***Subject: Nestlé Waters North America Inc. ("NWNA") Application for Permit Revision to 1041 Permit ("Permit") and Special Land Use Permit ("SLUP") Regarding Surface-Water and Groundwater Monitoring and Reporting Reduction***

## **Proposed Surface Water and Groundwater Monitoring and Mitigation Plan Ruby Mountain Springs and Bighorn Springs Sites Chaffee County, Colorado**

**December 1, 2014**

**Figure 4**  
**Monitoring Stations in the Surface- and Ground-Water Monitoring and Mitigation Plan**  
Ruby Mountain Springs, Chaffee County, Colorado

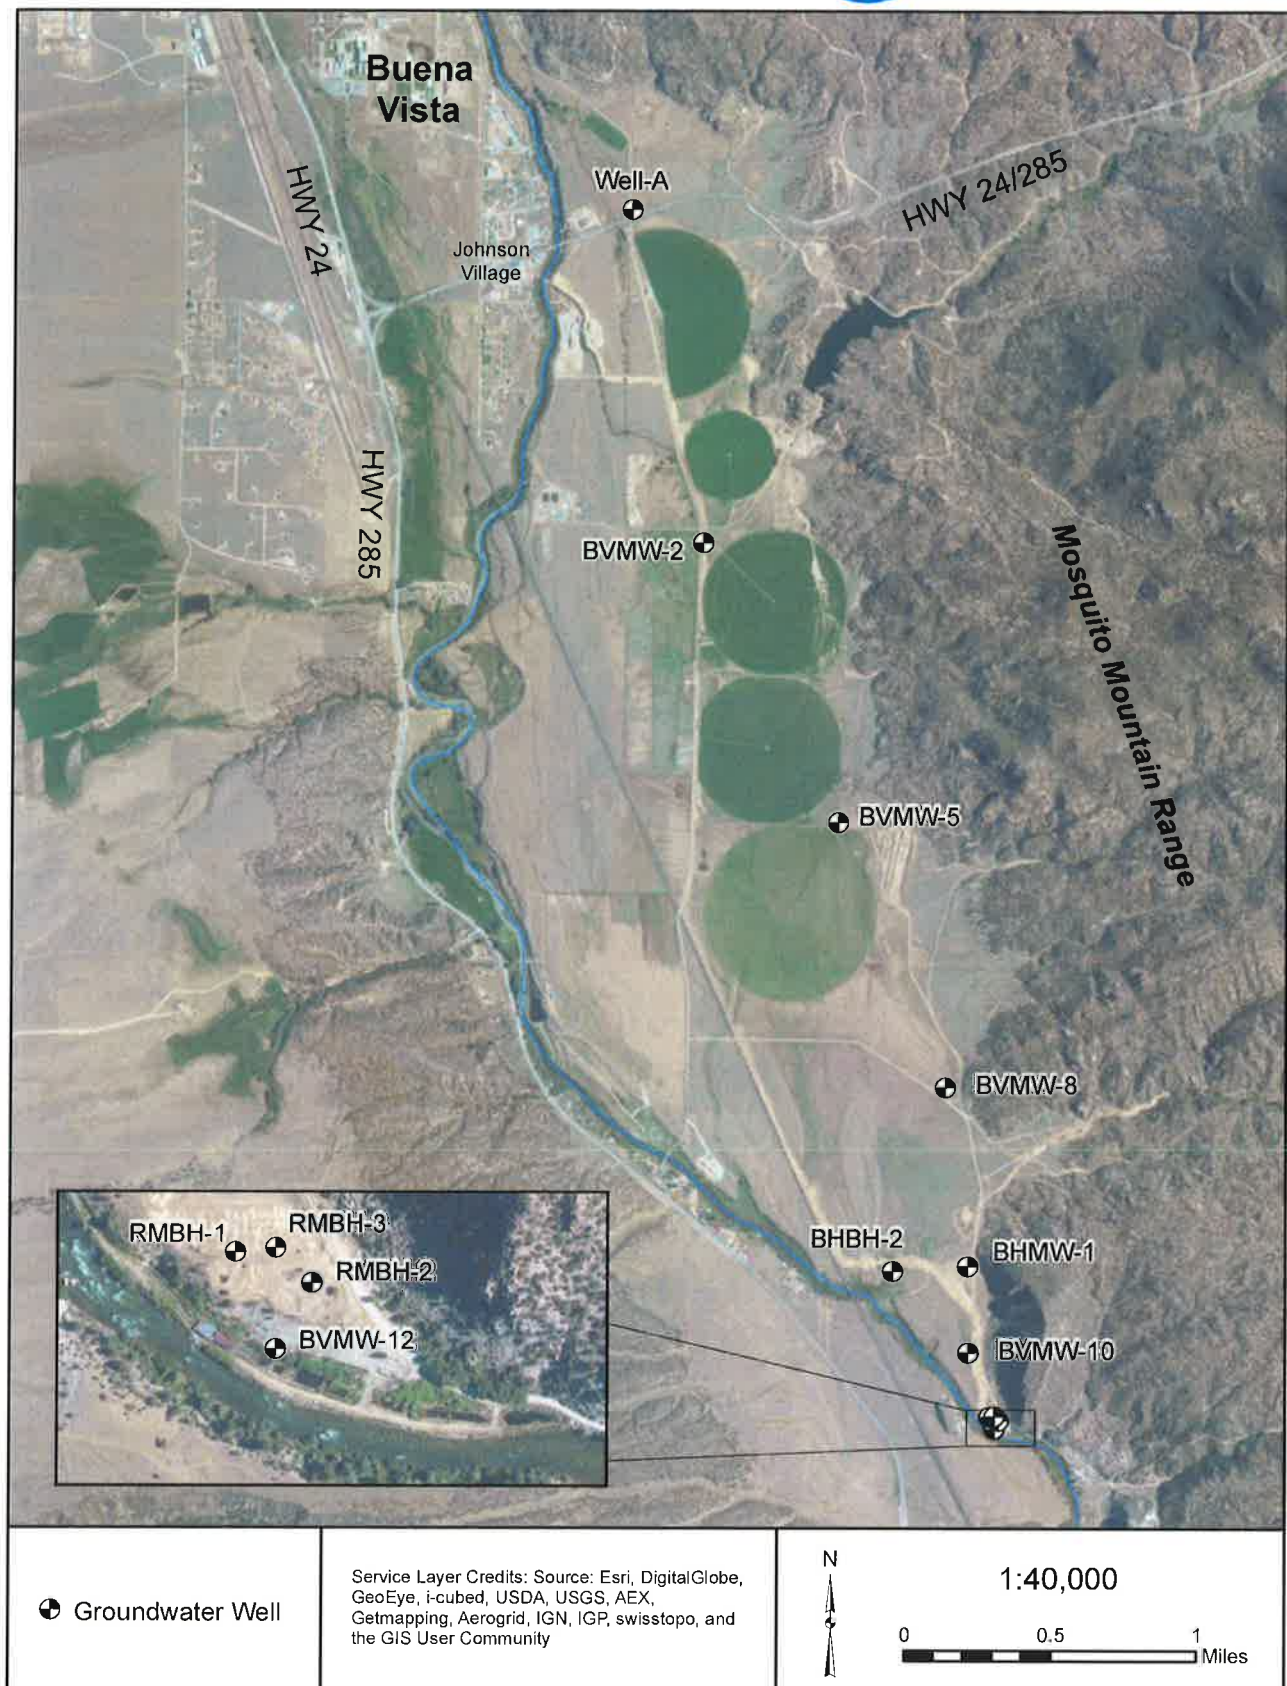
The only change in drawings or plans for this Technical Revision is a revised map showing the updated water monitoring structures in the proposed SWGWMMP (Exhibit 1).

Figure 1. Hydrograph of up-gradient monitoring wells.

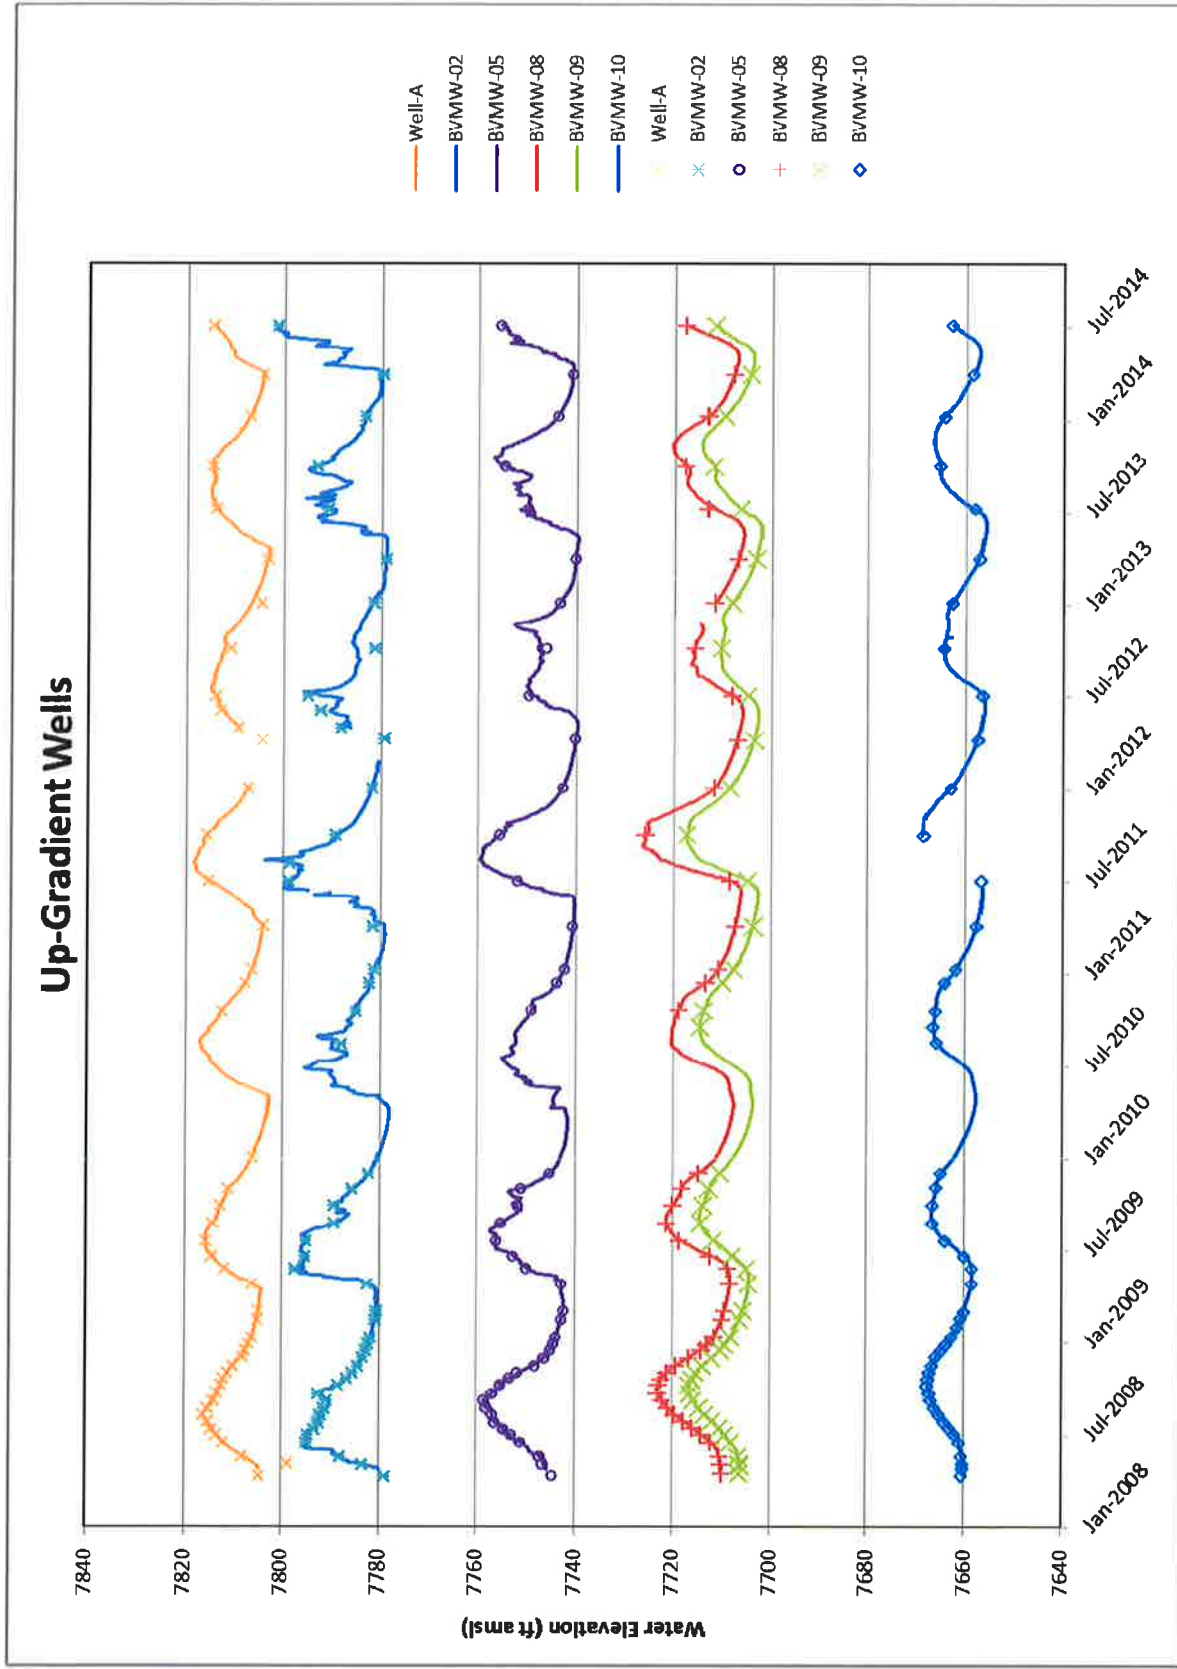
The monitoring well BVMW-9 is located on Colorado Department of Corrections (CDOC) land north of NWNA's Bighorn Springs (BHS) Parcel and is located in the western half of the surficial aquifer that feeds the Ruby Mountain Springs. All of the other monitoring wells that are in the SWGWMMP are along the eastern margin of the aquifer. Through historical monitoring measurements collected to date, NWNA has determined that the wells along the eastern portion of the aquifer along the front of the crystalline rocks of the Mosquito Range tend to have water chemistries more similar to that observed in the Ruby Mountain Springs water. The water chemistry from wells in the central to western portion of the aquifer appears to be more significantly influenced by irrigation than wells along the eastern margin of the aquifer. Additionally, BVMW-8 and BVMW-9 are at approximately equal positions on the north-to-south hydraulic gradient, so the groundwater levels measured in these well are almost equivalent (see hydrograph in Figure 1 in Exhibit 2). Water-level measurements from BVMW-9 appear to be largely redundant to measurements from BVMW-8.

Therefore, NWNA requests that the County approve the cessation of monitoring and reporting from well BVMW-9. NWNA does not intend on abandoning this well at this time, but will provide to the County a copy of the Colorado Division of Water Resources (CDWR) Well Abandonment Report when it is abandoned.

# Figure 4

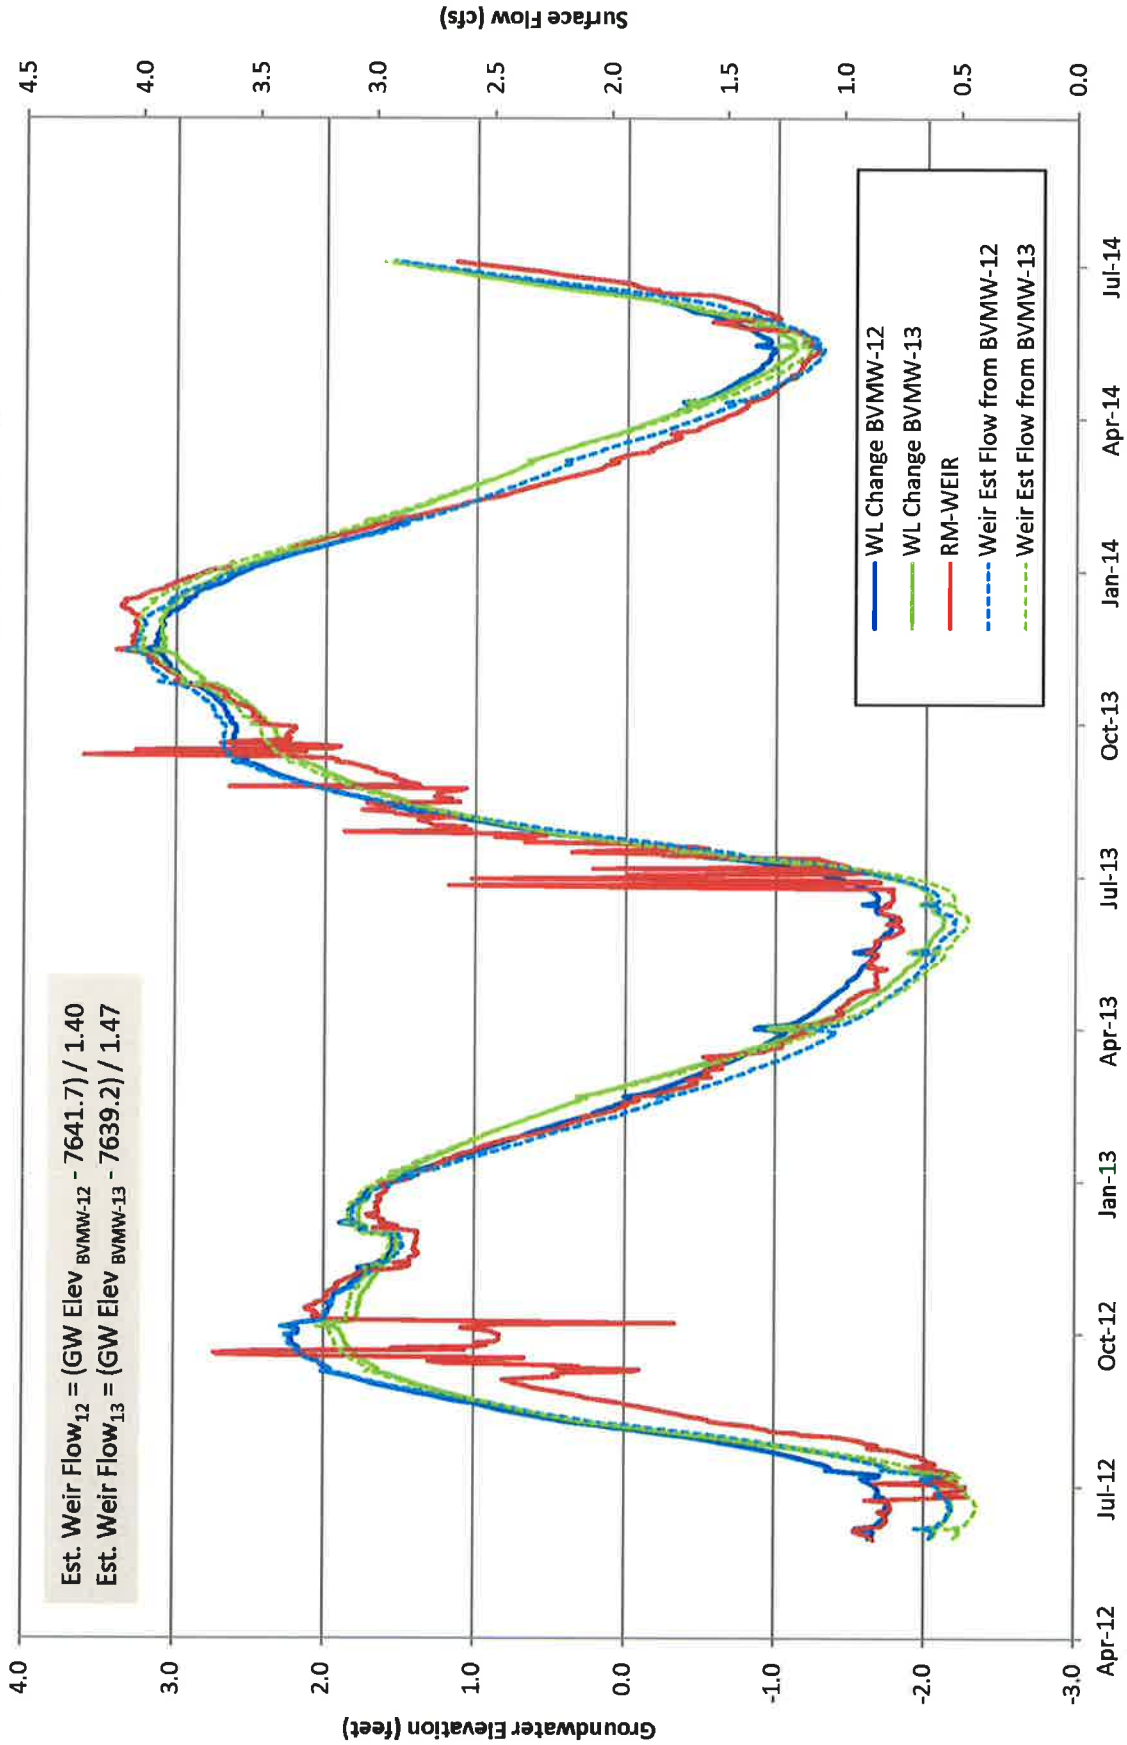
Figure 4 of Exhibit 3 shows the superimposition of these hydrographs with a calculated weir flow based on water-level measurements from each of these wells. (The calculated flow curves were obtained through a statistical correlation, with obvious flow outliers removed, and resultant equations [shown on figure] relating flows with water-levels.) It can be seen that the water-level data quite accurately reflect measured

surface flows. However the “predicted” surface flows also are subject to the lag seen in the hydrographs.

Therefore, NWNA requests that the County approve the cessation of monitoring and reporting from the RMS weir and replace those measurements with calculated spring flows through the pond/channel system based on water-level measurements from BVMW-12.

Figure 5 - Ruby Mtn Calculated Spring Flow  
(based on RMBH1 - BVMW-12 gradient for post-reclamation, 2012 data)

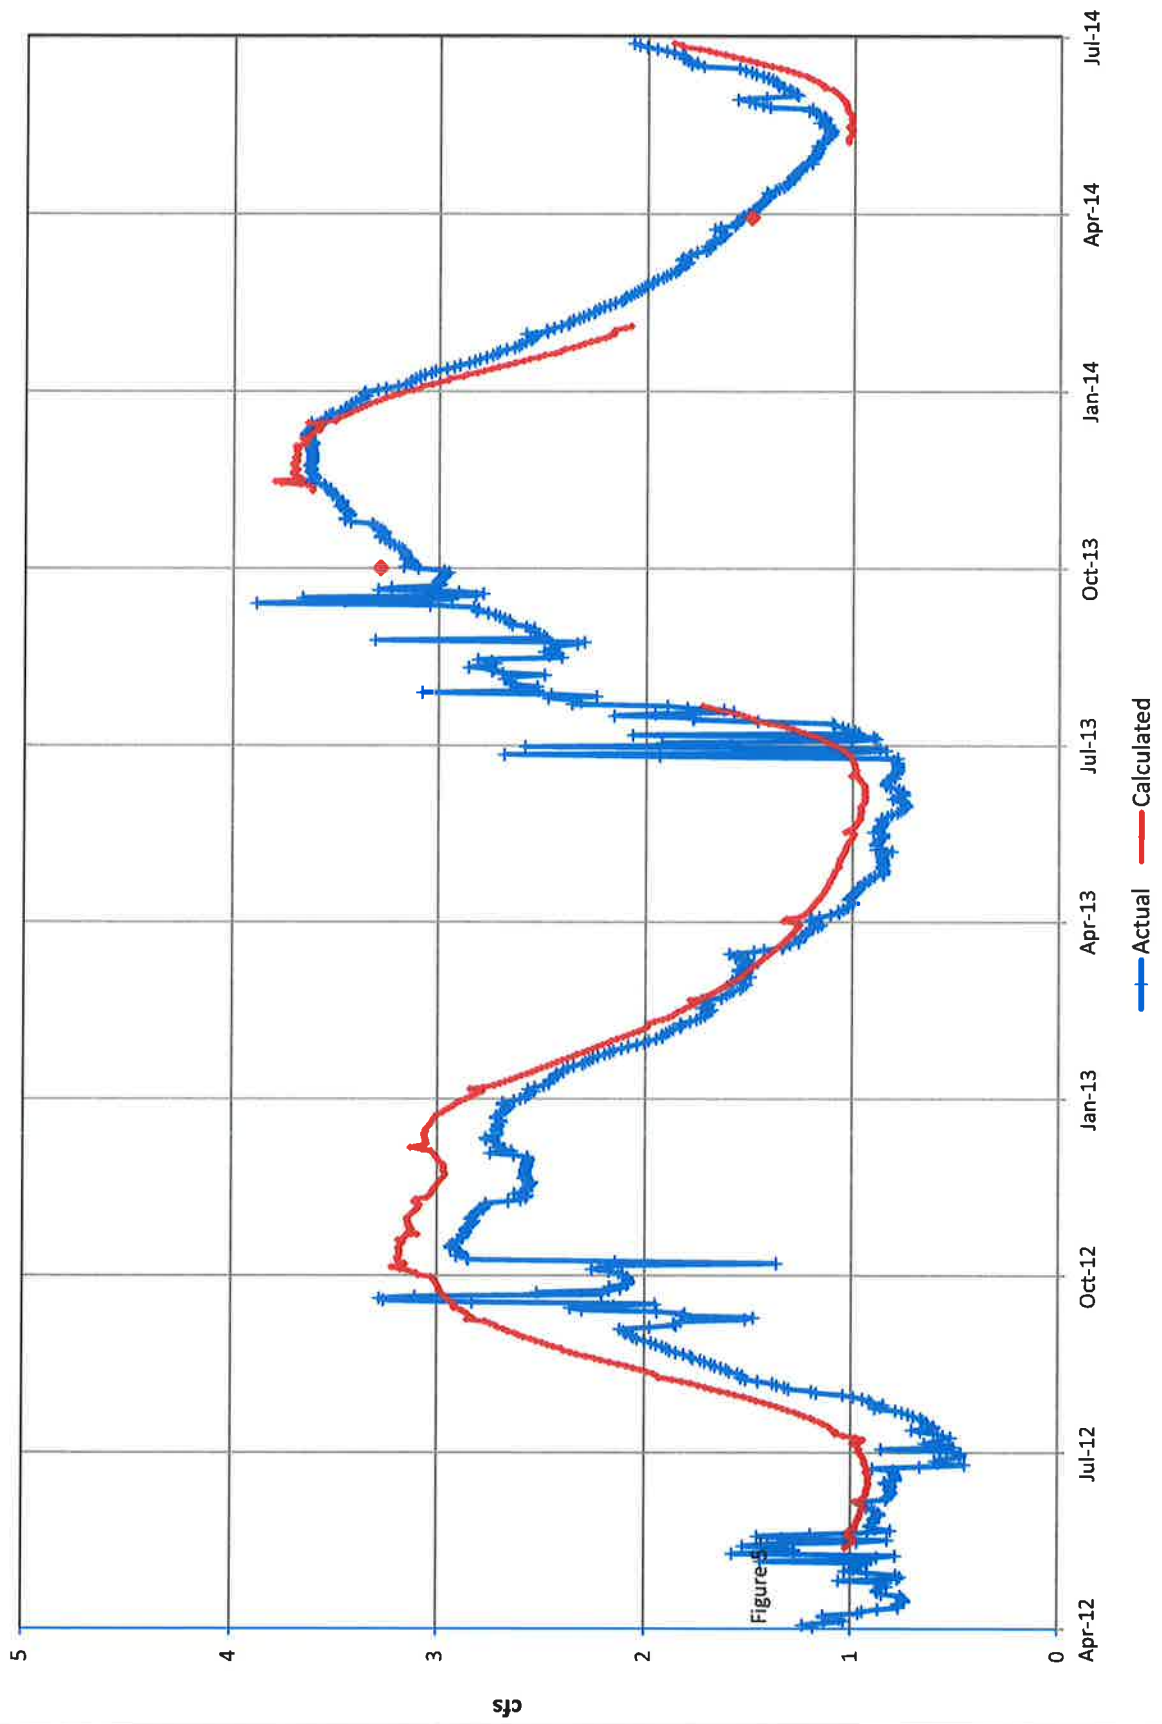
Figure 5 of Exhibit 3 shows “predicted” weir flows based on water-level measurements from BVMW-12 and BVMW-13 in relation to actual weir flows based on a correction for lag in flows based on a gradient calculation. It can be seen that calculated weir flows based on water-level data from BVMW-12 more accurately reflect actual weir flows. NWNA submits, from this correlation analysis, that calculated spring flows through the pond/channel system based on water-level measurements from BVMW-12 are sufficiently accurate relative to the magnitude of normal fluctuations in flows from season to season and from year to year that direct measurements of flows from the weir are unnecessary.

Figure 1  
Ruby Mountain Springs  
Upper Hagen Flume Measured Flow

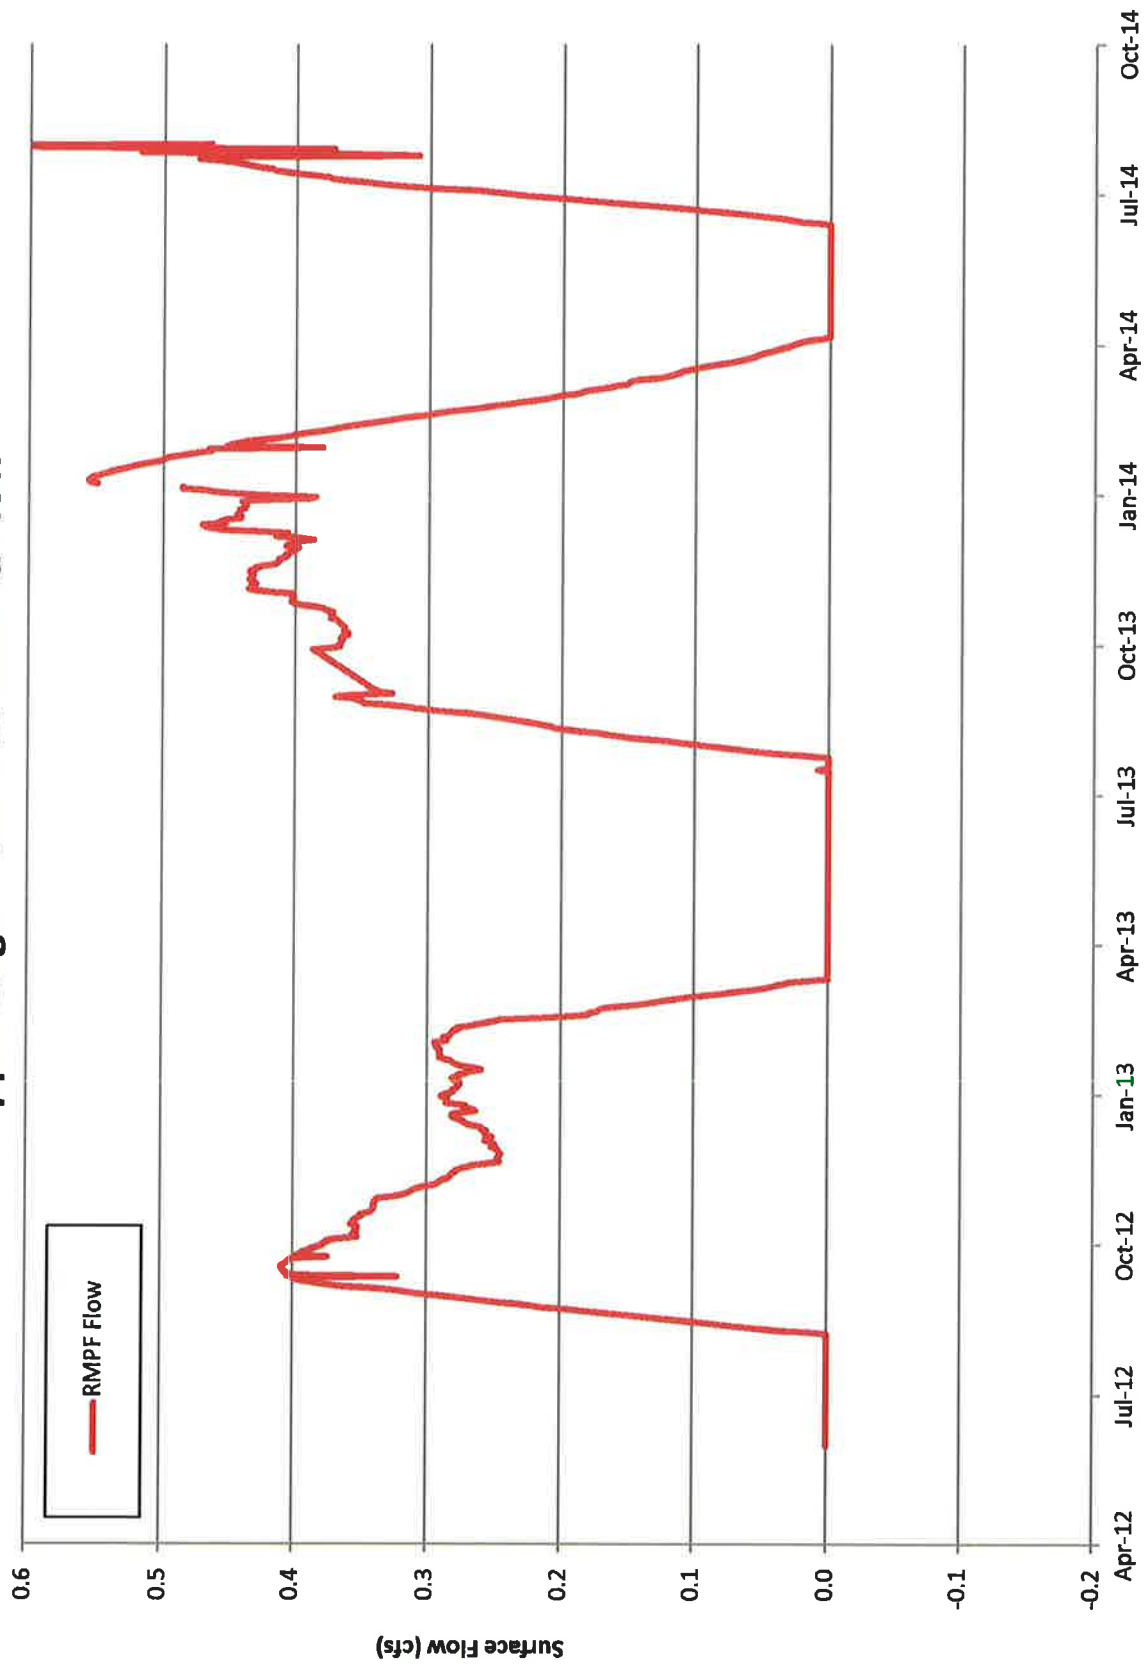
Figure 1 of Exhibit 4 presents measured flows from the Upper Flume post-reclamation for the period June 2012 through July 2014. It can be seen that the upper ditch does not flow for a significant portion of the year typically between May through June and sometimes into July. When the upper ditch does flow, measured flows through the flume are erratic being subject to blockages from aquatic weed growth and beaver activity; surface runoff events from precipitation, and losses due to freezing and overflow of the upper ditch.

Therefore, NWNA requests that the County approve the cessation of monitoring and reporting from the RMS Upper Flume and replace those measurements with calculated flows through the upper ditch based on water-level measurements from BVMW-12. NWNA intends to monitor and report these calculated flows for as long as NWNA operates its Ruby Mountain Springs project and as long as the upper ditch is maintained and allowed to operate by its owner. Upon abandonment of the upper ditch by its owner, NWNA will cease reporting calculated flows for the Upper Flume.
